SUBJECT: Requests relief from certain requirements of ASME Section XI associated w/partial exams conducted during 1995 plant refueling outage ISI.

**VIRGINIA ELECTRIC AND POWER COMPANY**  
**SURRY POWER STATION UNIT 2**  
**INSERVICE INSPECTION PROGRAM RELIEF REQUESTS**

**Attachment 1**  
**Surry Power Station Unit 2**  
**ISI Examination Relief**

Figure SR-22-1

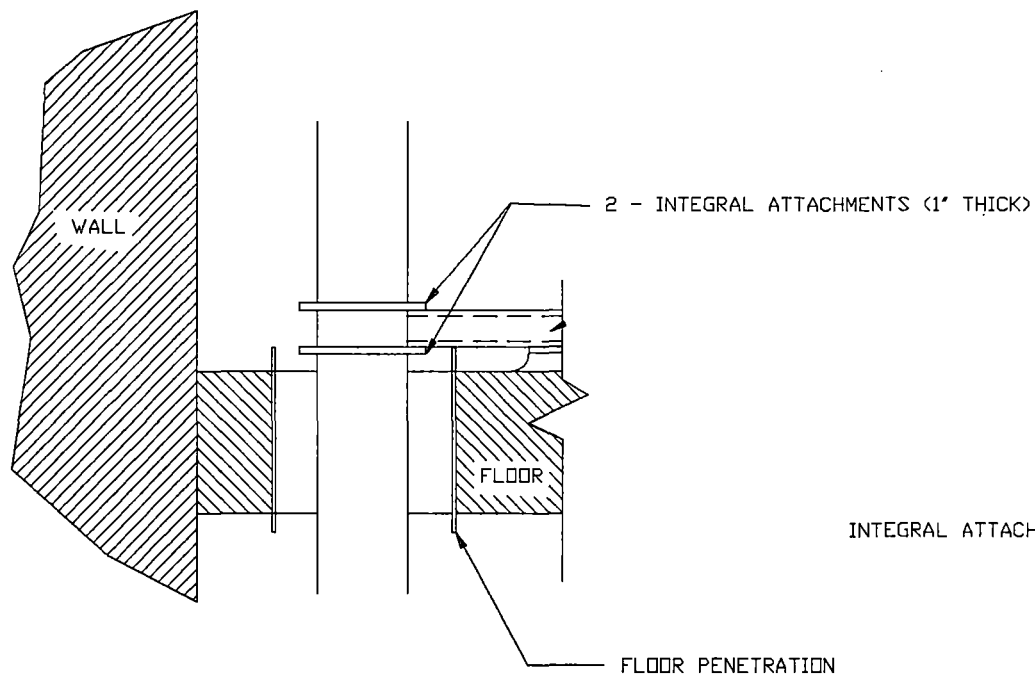
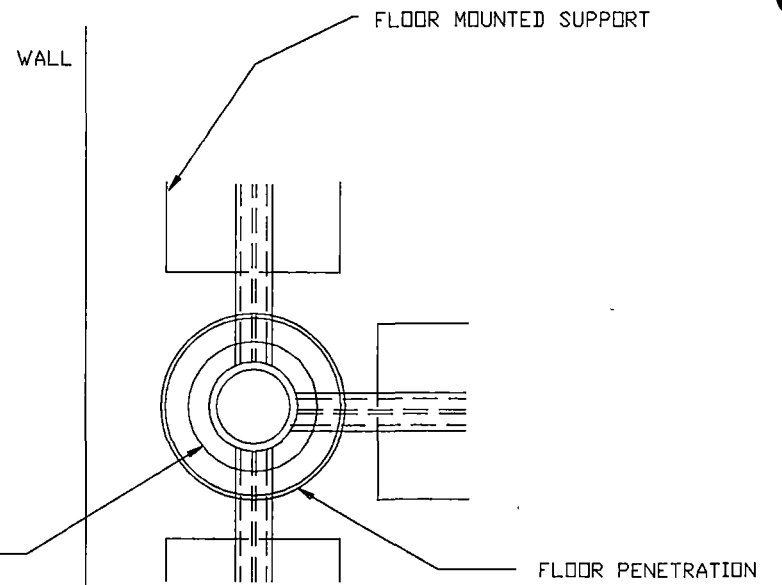
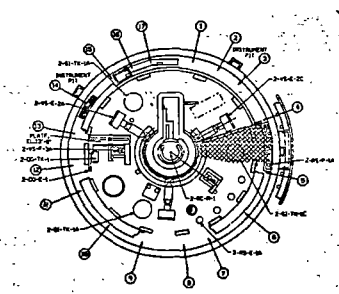
The components listed above has been examined to the extent practical as required by the Code. Due to interferences from pipe support structures and the location of the supports at the point where the pipe passes through the floor, a reduction in coverage of the surface examinations of 50% was necessary. Figure SR-22-1 is provided detailing the limitations experienced. The figure is similar for both support structures. Alternative components could not be substituted for examination due to the mandatory selection requirements of the Code.

It is proposed that the examination already completed at the reduced coverage be counted as meeting the Code requirements.

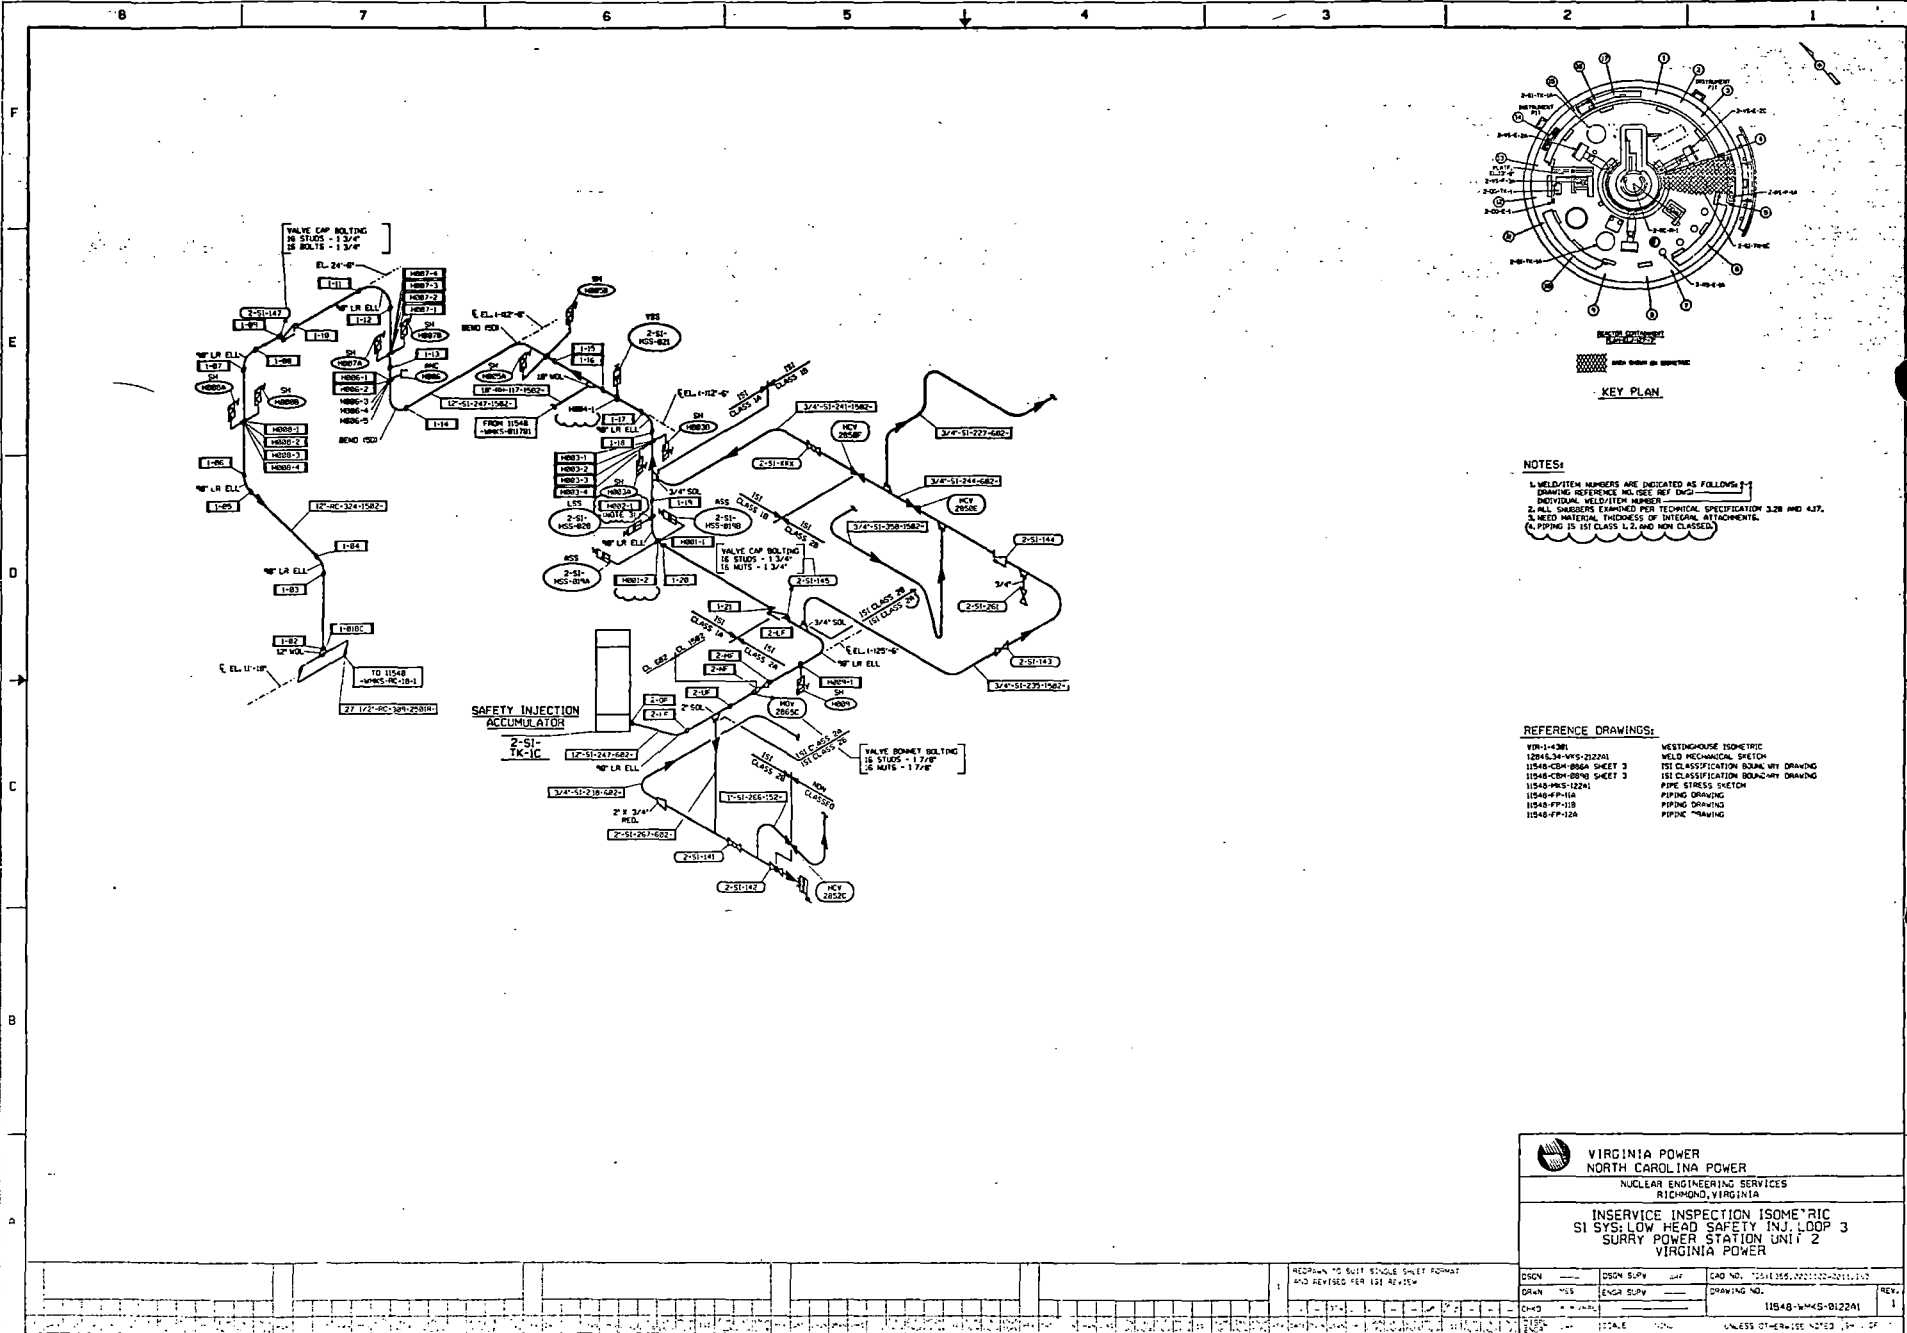
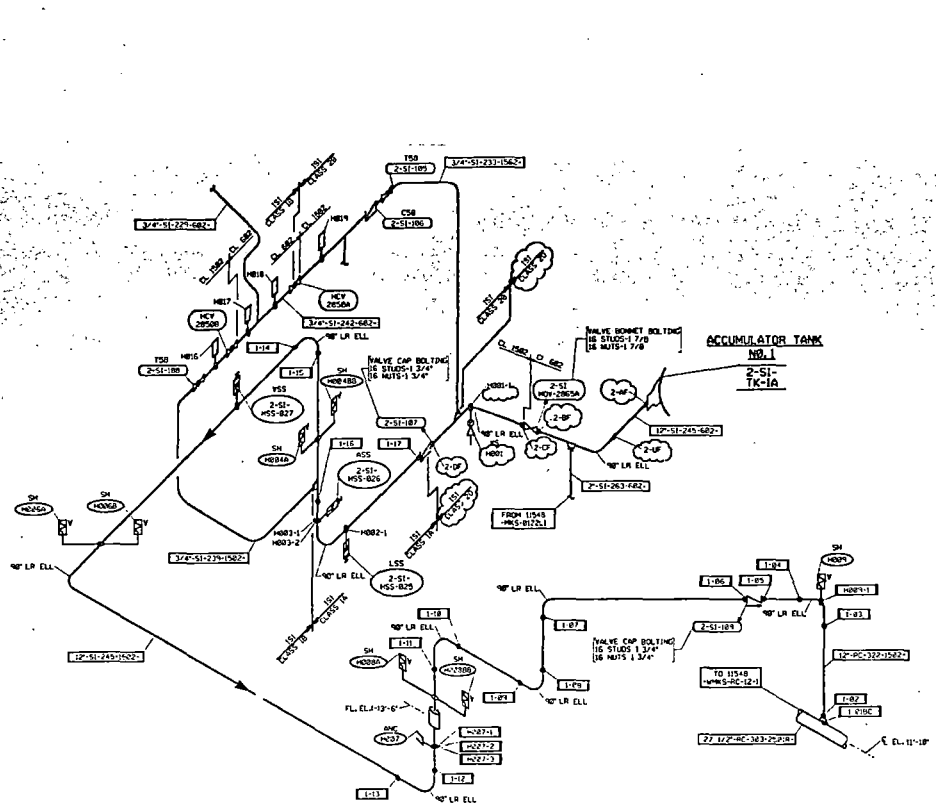
<u>Mark/Weld#</u>	<u>Line#</u>	<u>Drawing#</u>	<u>Class</u>
H-006	12"-SI-247-1502	11548-WMKS-122A1	1
H-007	12"-SI-245-1502	11548-WMKS-122L1	1

DSGN	DSGN SUPY	ARF	CAD NO.	CHE000003
DRWN	DISPL ENGR	WFM	DRAWING NO.	11548-WMKS-CH-E-3
CHKD	LEAD ENGR		REV.	1
DATE 3/27/90			SCALE NONE	UNLESS OTHERWISE NOTED

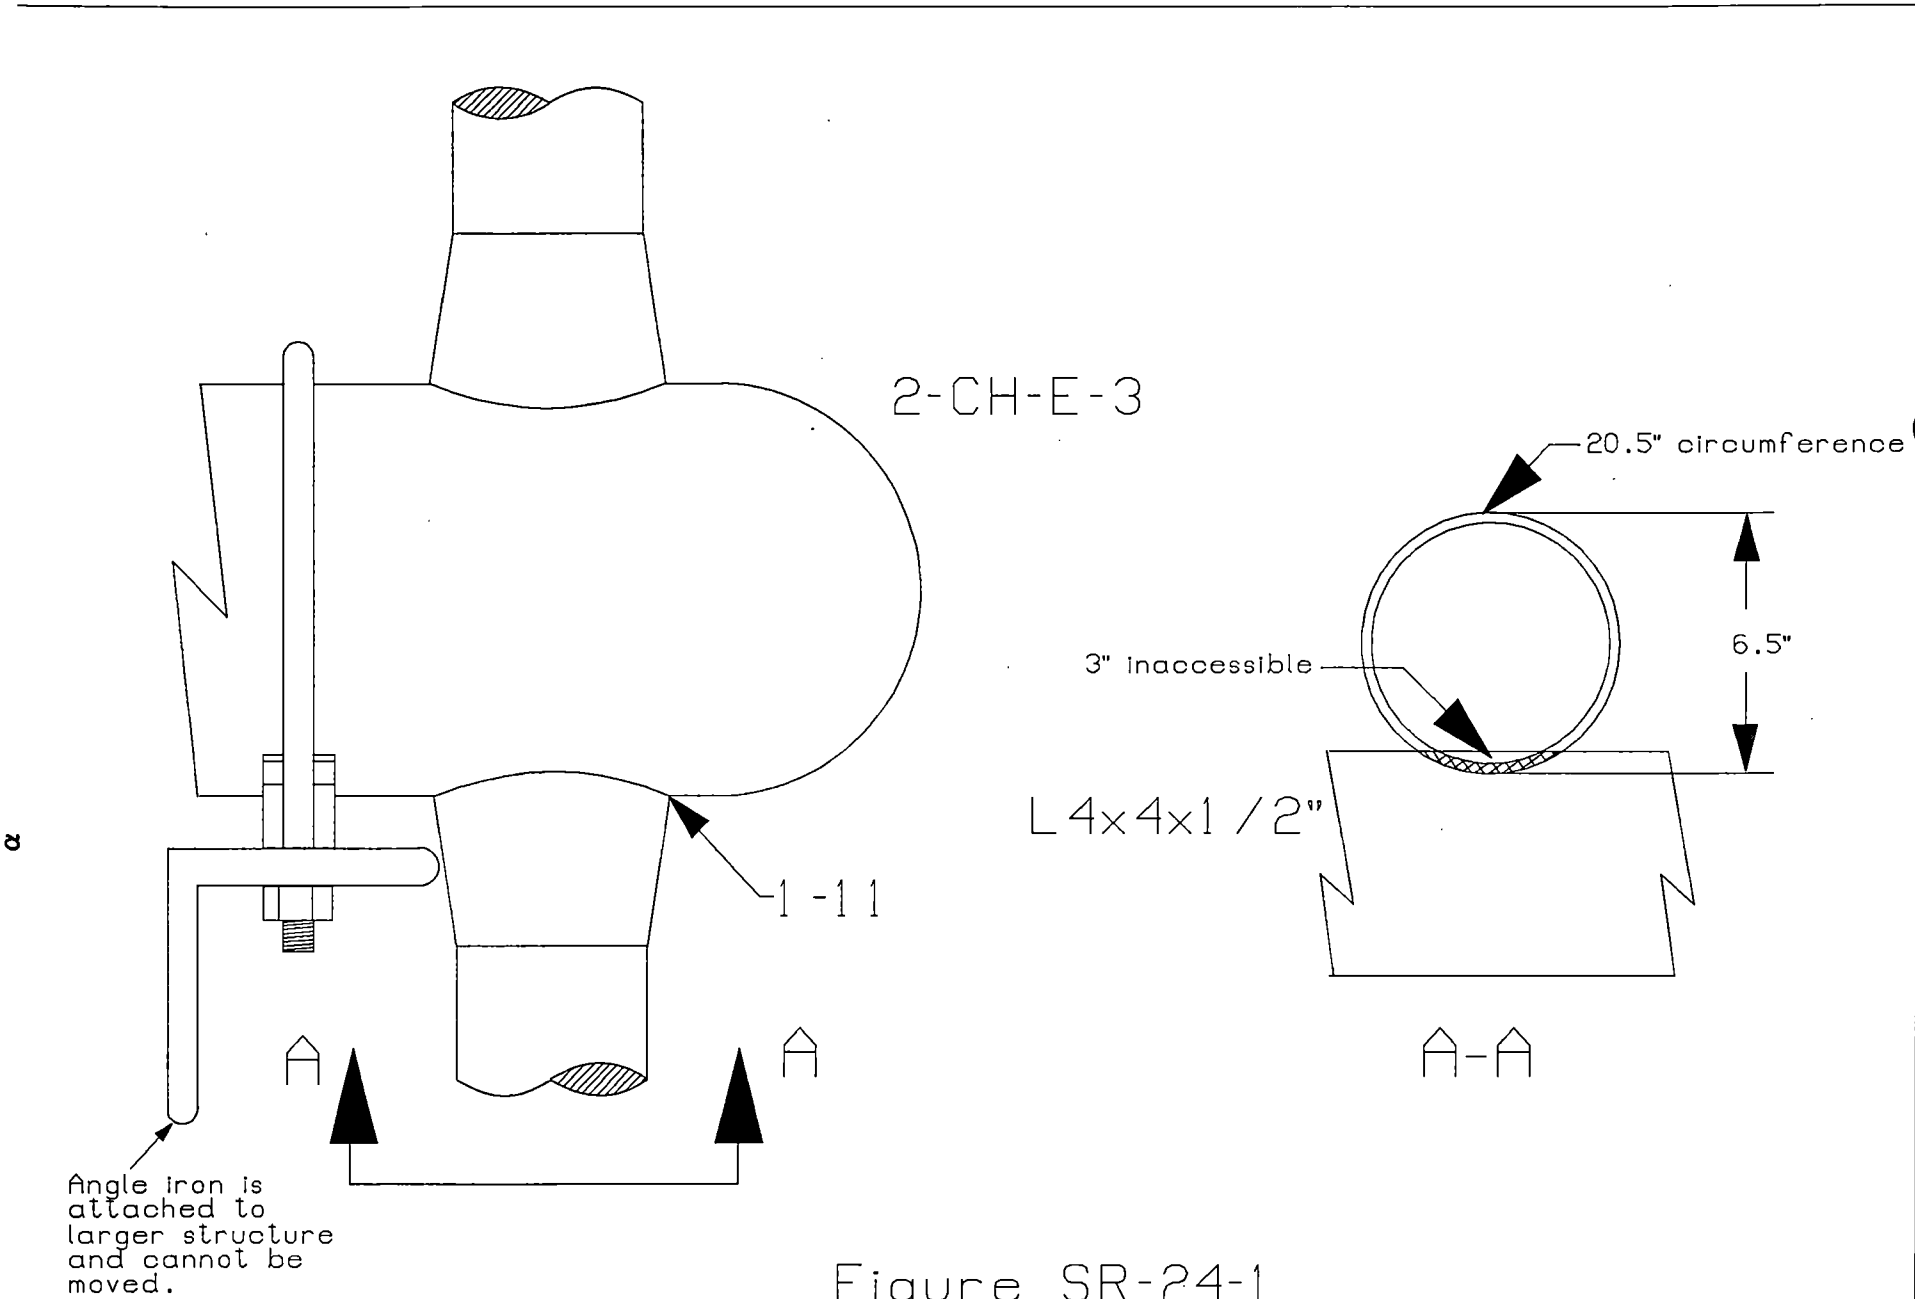
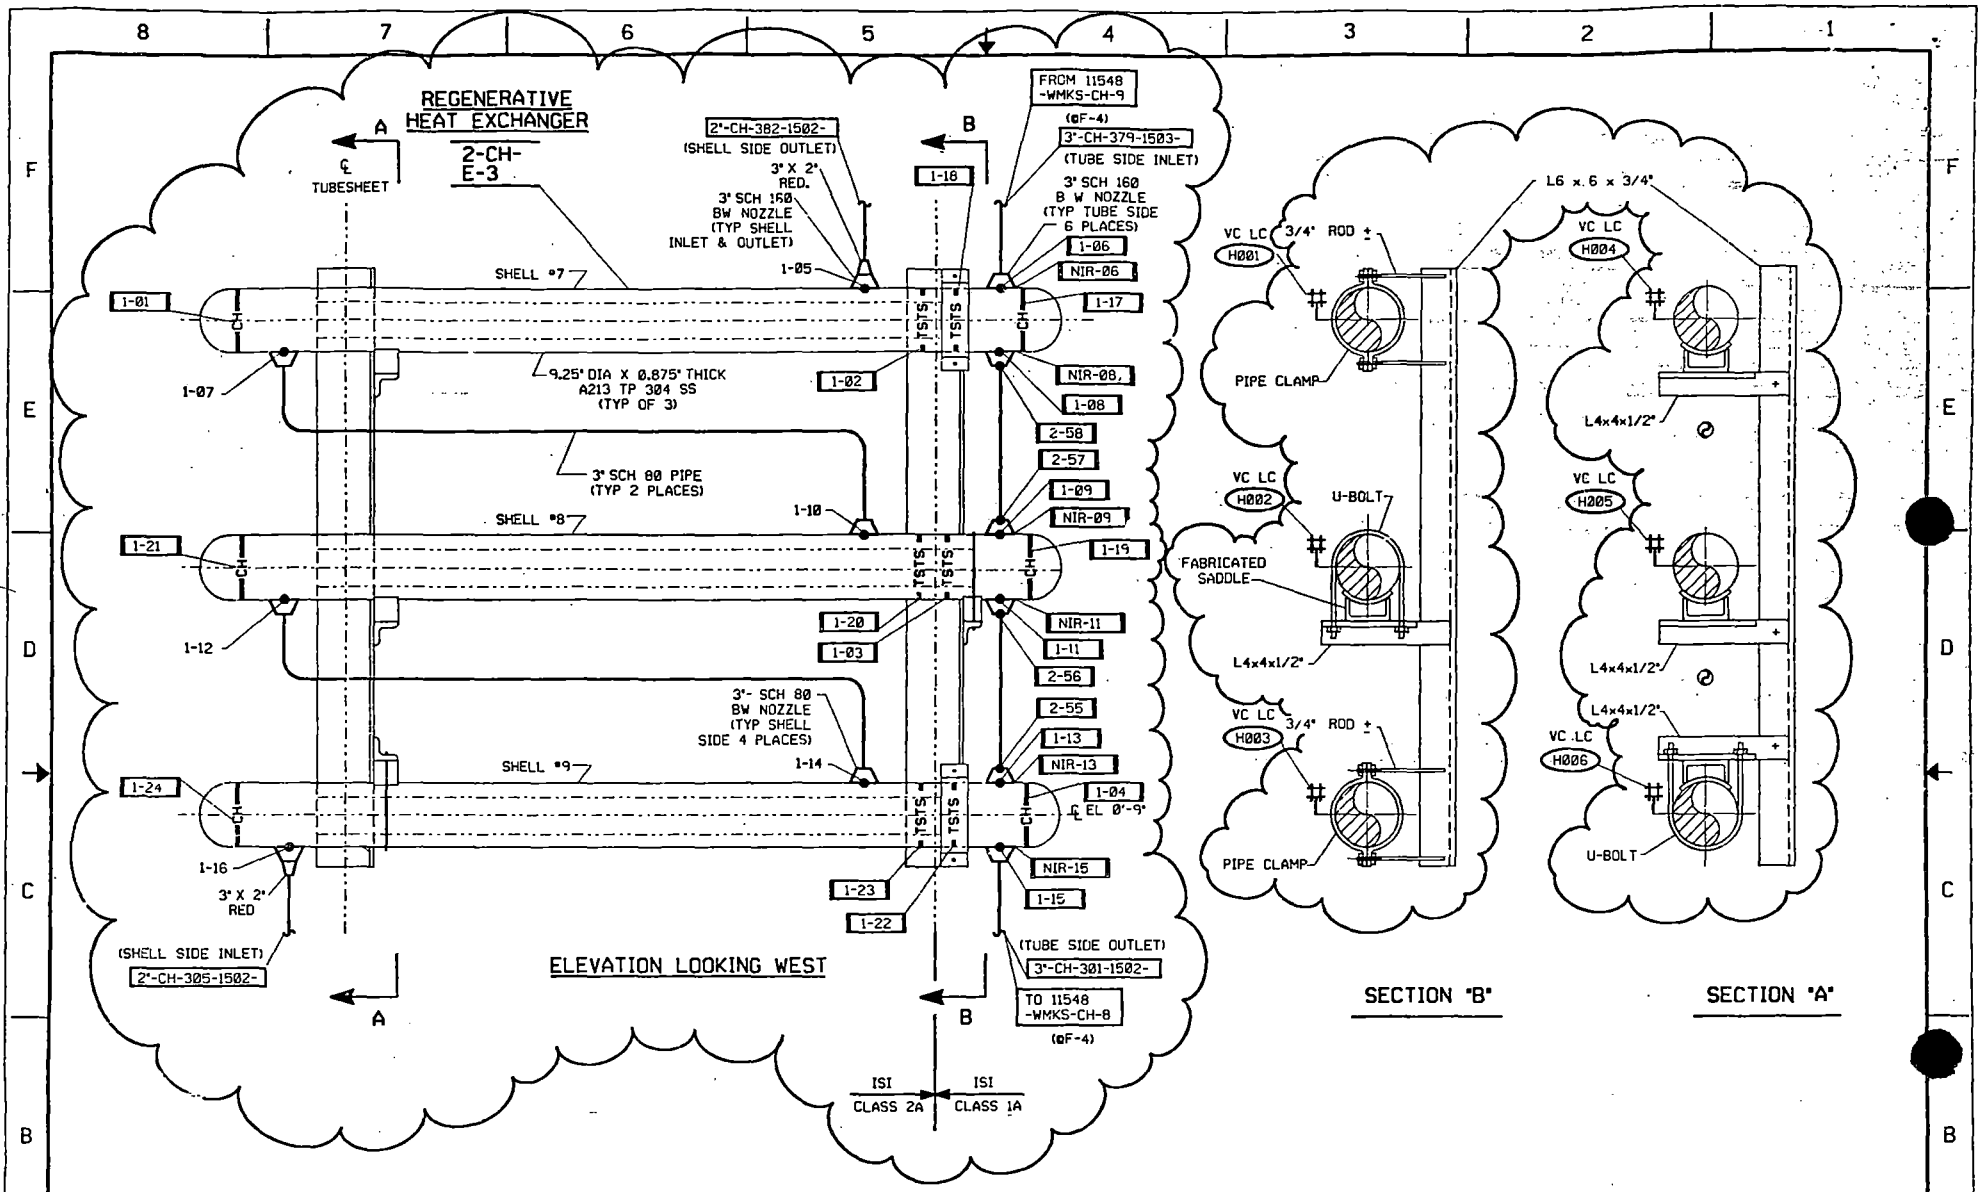
The component listed above has been examined to the extent practical as required by relief request SR-018 of the Inservice Inspection Program for Unit 2 Second Interval. Due to interferences from a support clamp the reduction in coverage of the surface examination was 14.6%. Figure SR-23-1 is provided detailing the limitations experienced. Alternative components could not be substituted for examination due to the mandatory selection requirements of the Code.

It is proposed that the examination already completed at the reduced coverage be counted as meeting the Code requirements.

Figure SR-24-1

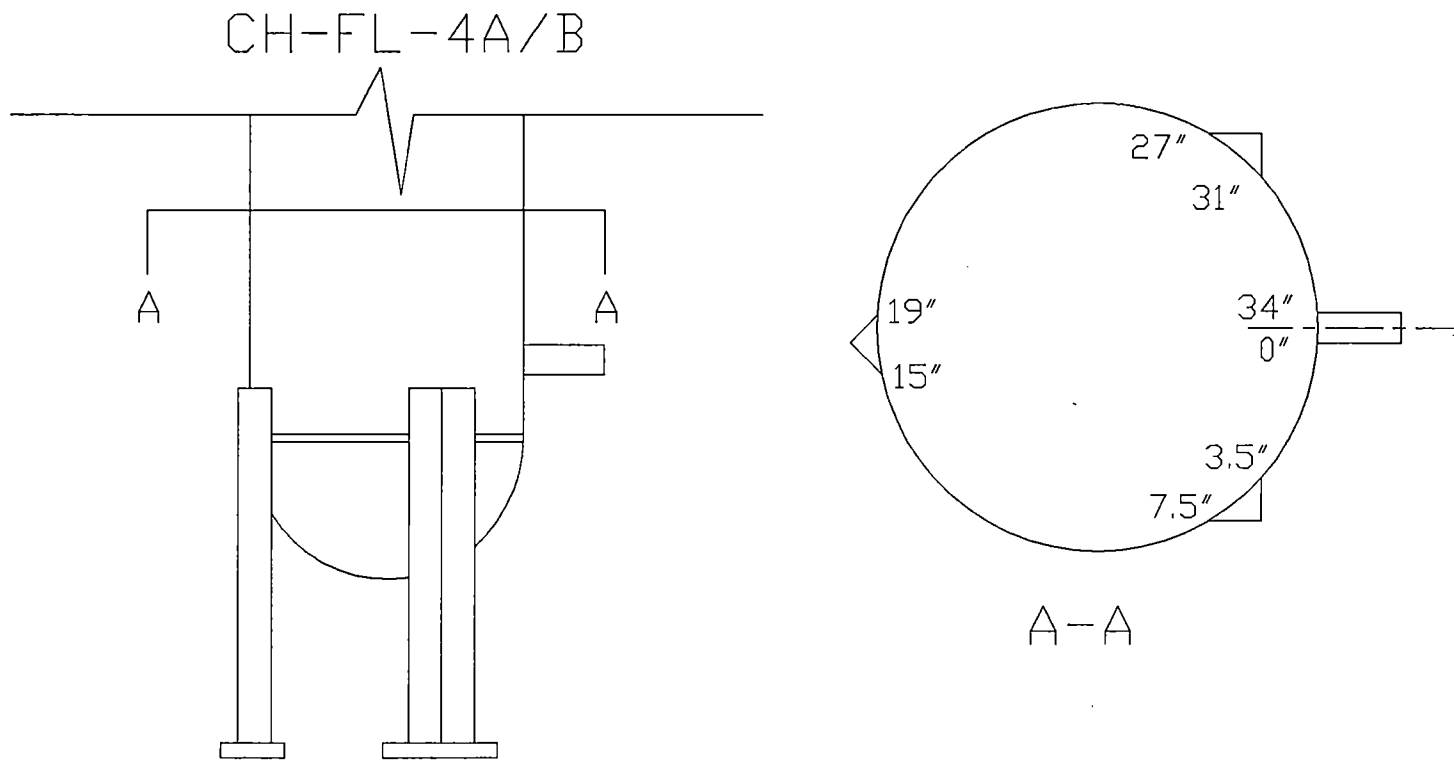
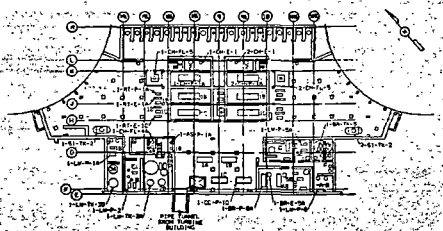
The component listed above has been examined to the extent practical as required by the Code. Due to interferences from three permanent support legs the reduction in coverage of the ultrasonic examination was 35% (12" out of 34"). Figure SR-24-1 is provided detailing the limitations experienced. Alternative components could not be substituted for examination due to the mandatory selection requirements of the Code.

It is proposed that the examination already completed at the reduced coverage be counted as meeting the Code requirements.
